AERONAUTICAL CHARTING FORUM
Instrument Procedures Group
Meeting 15-01 – April 28, 2015

RECOMMENDATION DOCUMENT

FAA Control # 15-01-321

Subject: Coding of Missed Approach for ILS 31L and ILS 31R at KJFK

ILS or LOC RWY 31L

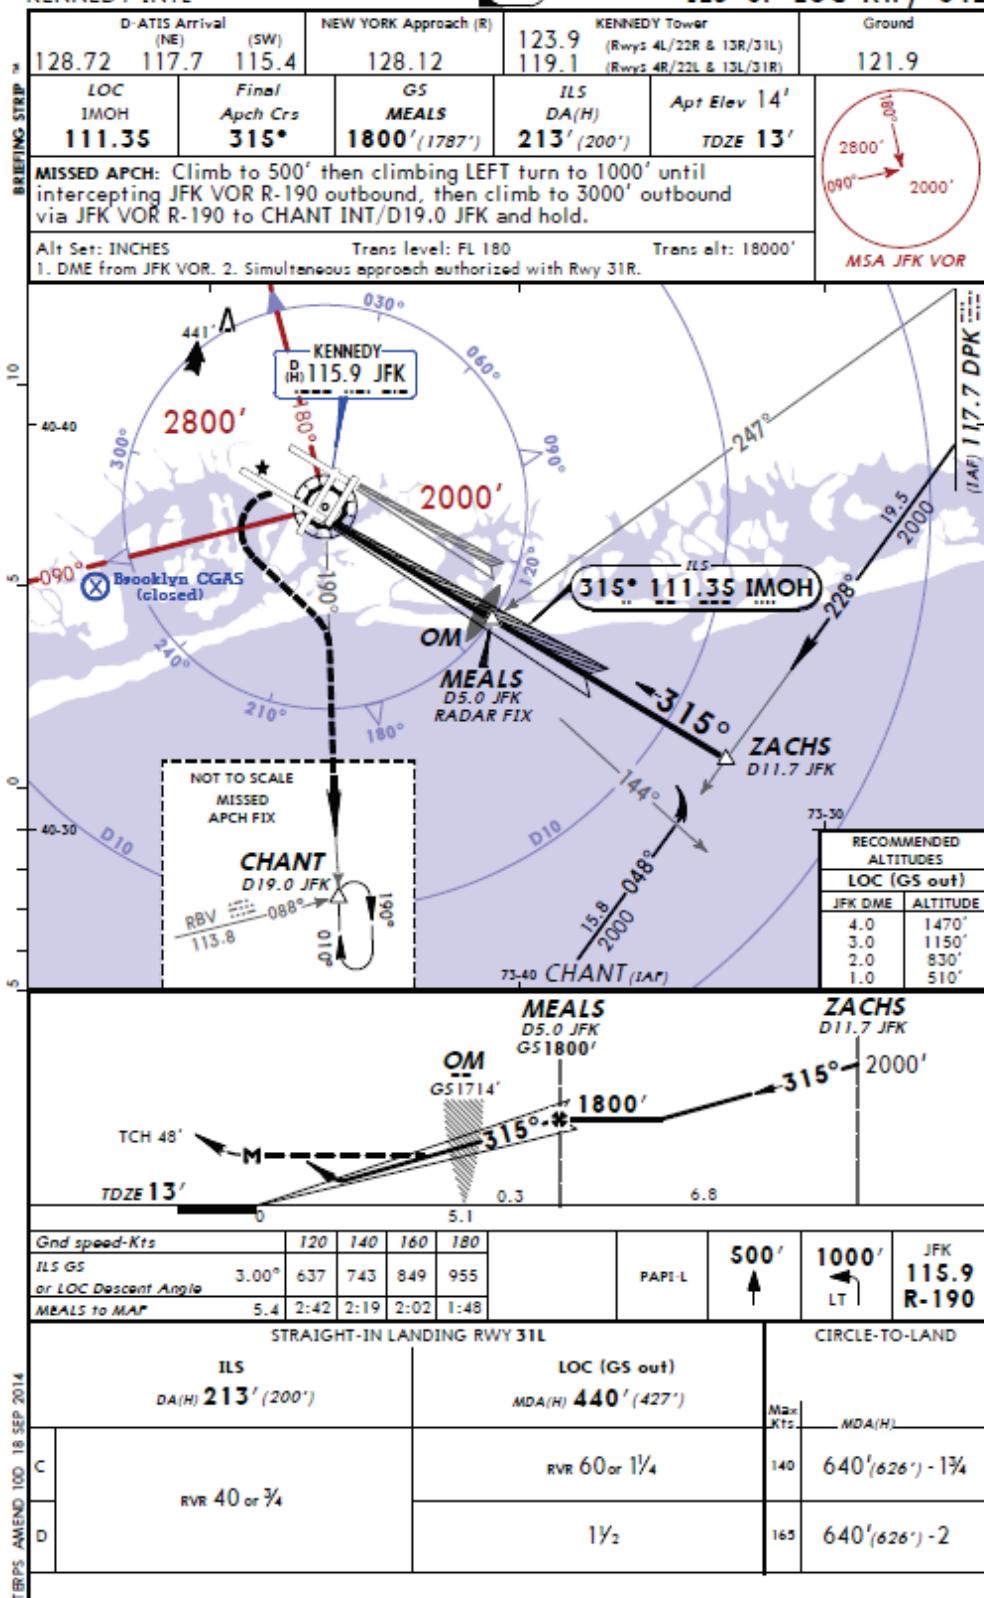
Background/Discussion: It was recently discovered by an airline crew that the missed approach for the ILS 31L and ILS 31R at KJFK does not appear to be coded correctly in the FMS database. The coding and text on the approach chart do not match and is causing confusion in the cockpit. The FMS coding indicates these are “At or Above” altitudes, however the text indicates the intent of these to be coded as “At” altitudes. It seems that the “at” altitude is indeed providing procedural separation the way it is described. Investigation with Aeronautical Information Services (AIS) and Jeppesen revealed that the text description indicates a level off, but the actual coding indicates “at/above or minimum.” FAA Form 8260-3 states that “Altitudes are minimum altitudes unless otherwise indicated.” However, when it comes to the text used to describe missed approach instructions, Order 8260.19F, paragraph 8-6-7d Note, states:

Recommendations: Unlike RNAV procedures that are accompanied with ARINC coding information with the procedure, non-RNAV procedures do not. Recommend that database coding authorities become familiar with and comply with the use of the terms (i.e., “and” vs. “then”) used when coding conventional instrument procedures as defined in Order 8260.19F, paragraph 8-6-7d Note.

ILS or LOC RWY 31R
JOHN F KENNEDY INTL (JFK)

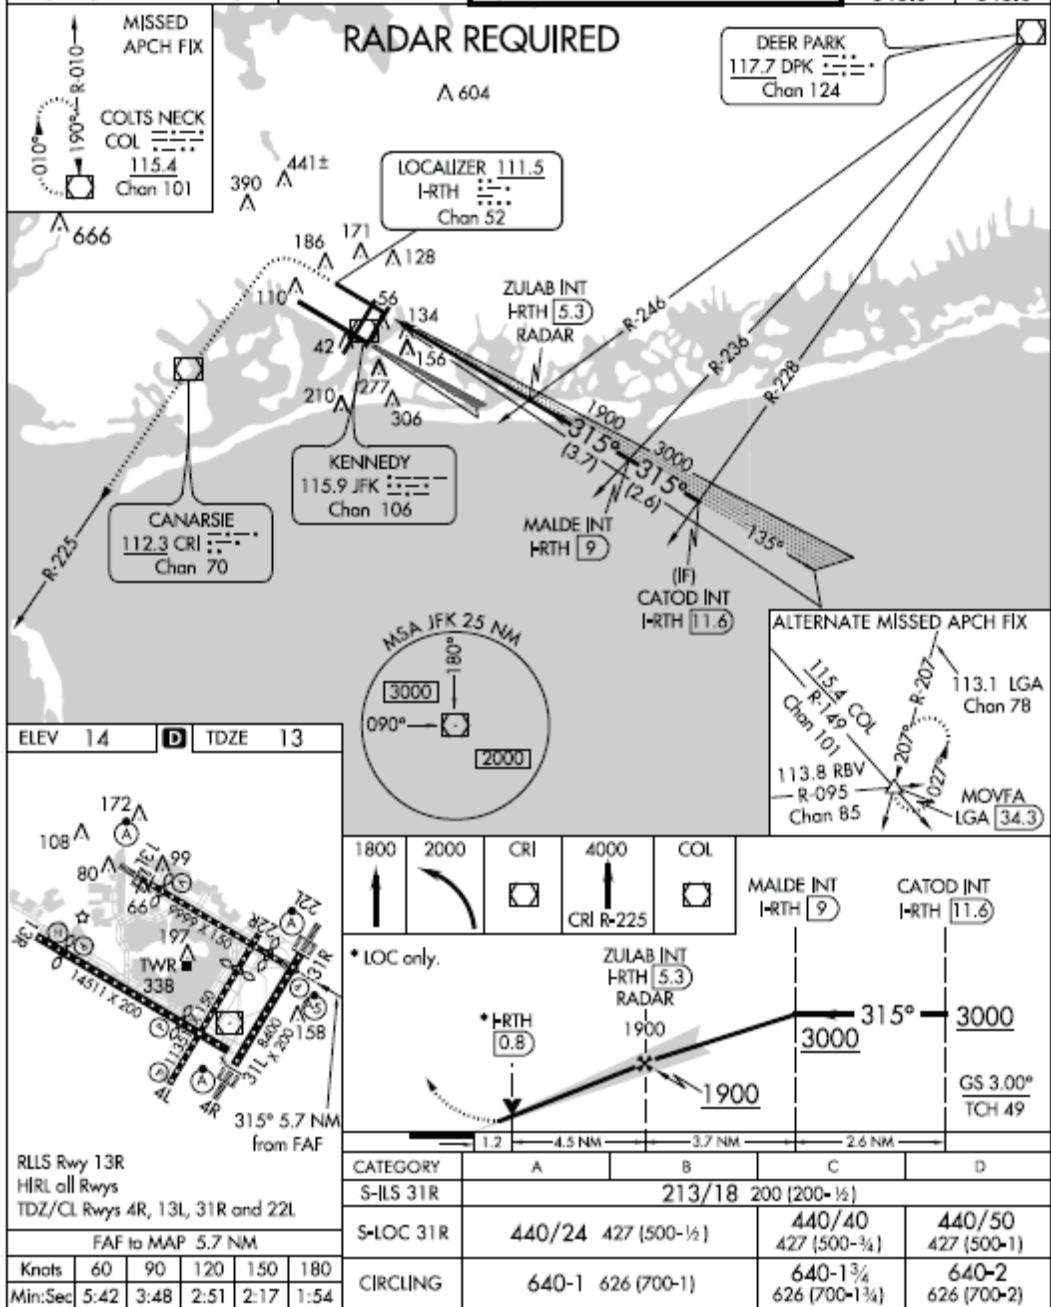
MISSING APPROACH: Climb to 1800 then climbing left turn to 2000 direct CRI VOR/DME then climb to 4000 via CRI VOR/DME R-225 to COL VOR/DME and hold.

JOHN F KENNEDY INTL (JFK)
ILS or LOC RWY 31R

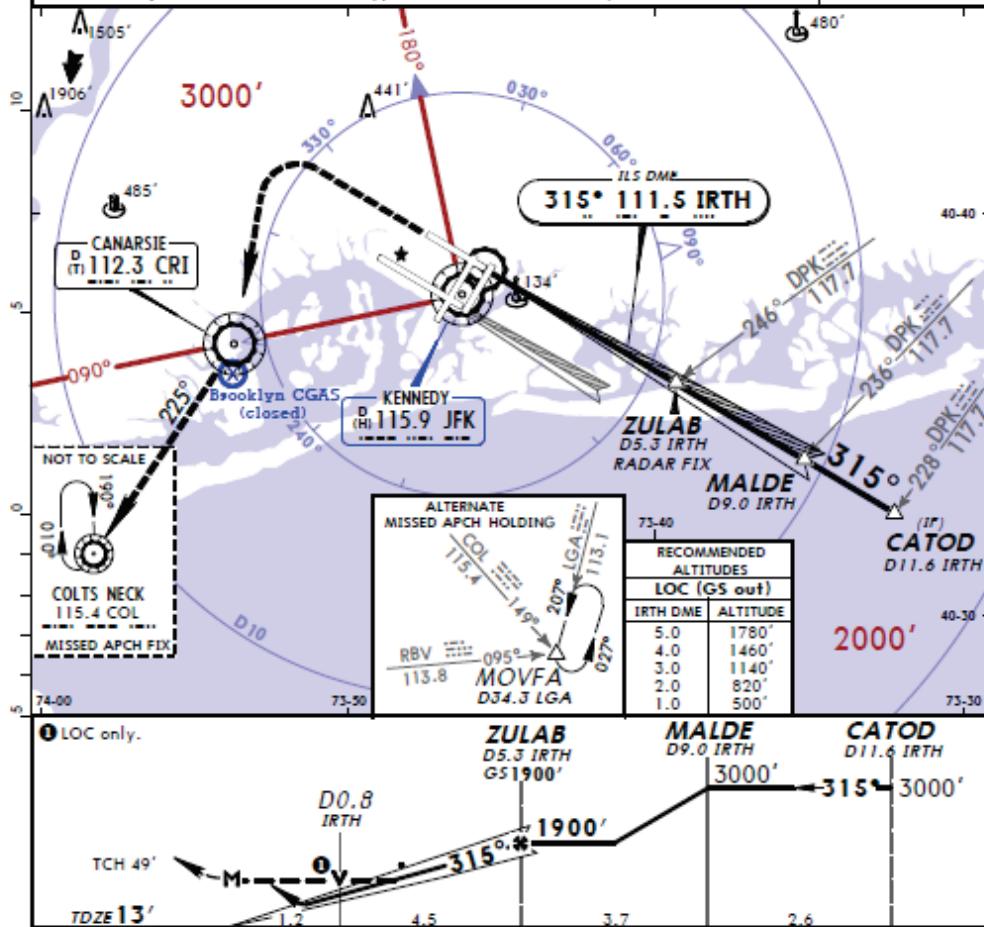
BRIEF MISSED APCH: Climb to 1800' then climbing LEFT turn to 2000' direct CRI VOR then climb to 4000' outbound via CRI VOR R-225 to COL VOR and hold, or as directed by ATC.
